# Service Bulletin

Bulletin No.: 23-NA-074

**Subject: Service Engine Soon (SES), Reduced Power, Service Brake, Reduced Steering and/or StabiliTrak Message Illuminated on Driver Information Center (DIC), DTCs P0232, P023F, P0641, P0651, P06A3, P0697, P07BE, P1000, P1009, P2535, P129D, P12A6, P12A8, P2635, P3051, P3052, P3055, P3056, P305B, U0074, U0077, U0121, U0131, U0151, U0415, U0420, U0672, U111A, U18A2, U18C6, U18D2, U2502, U2616, P07BF, P176C Set**

Brand:	Model:	Model Year:		VIN Breakpoint:		Engine:	Transmission:
		from	to	from	to		
Cadillac	XT5	2019	2023	—	—	All	All
	XT6						
Chevrolet	Blazer						
GMC	Acadia

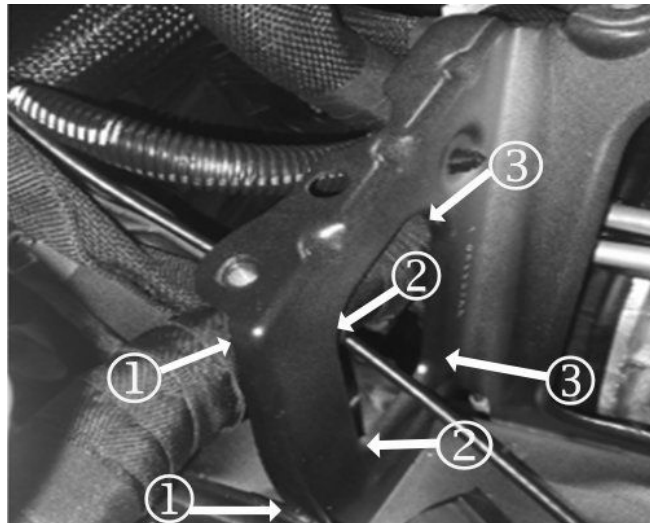
This condition may be caused by wire chafing on the battery tray support bracket.

1. Cut 76 mm (3") long strips of deadener and wrap around the edges on the battery tray bracket, as shown in the picture above.

2. Inspect the area near transmission cooler line bracket, as shown in the photo above. If damage is found, repair the harness, and secure it as necessary.

**Note:** If no damage is found in that area, follow the harness over to the area at the top of the control valve body cover, and inspect for damage to the harness that could be caused by one of the studs securing the cover.
